SERVICE BULLETIN

Date: 27 January 1999

Adjustment of click clutch in film processor

Fig. 1.

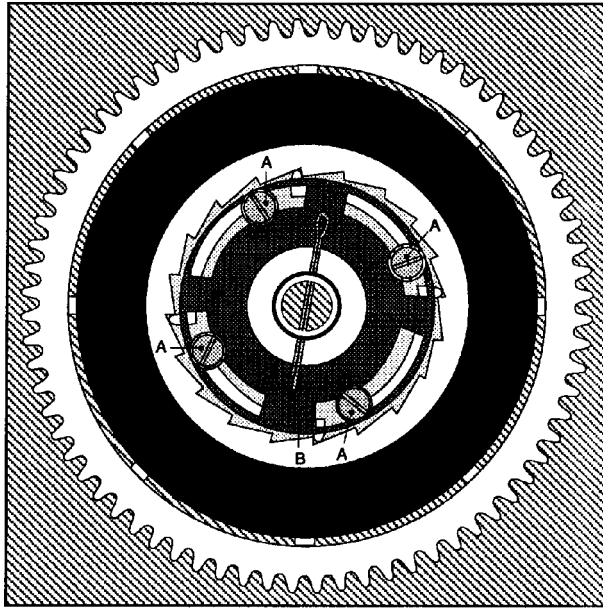
A) The four screws marked "A" are loosened in order to turn part "B" (Fig. 1.). This way distance "C" appears.

Fig. 2.

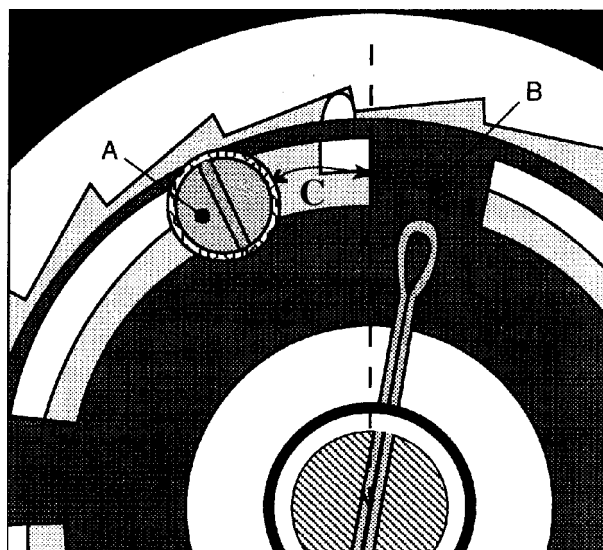
B) The distance "C" is adjusted as follows: **Dev/Fix/Wash rack $10,5 \pm 0,5\text{mm}$ (Fig. 2.)**
Dryer rack $8,5 \pm 0,5\text{mm}$

C) The screws are tightened again.
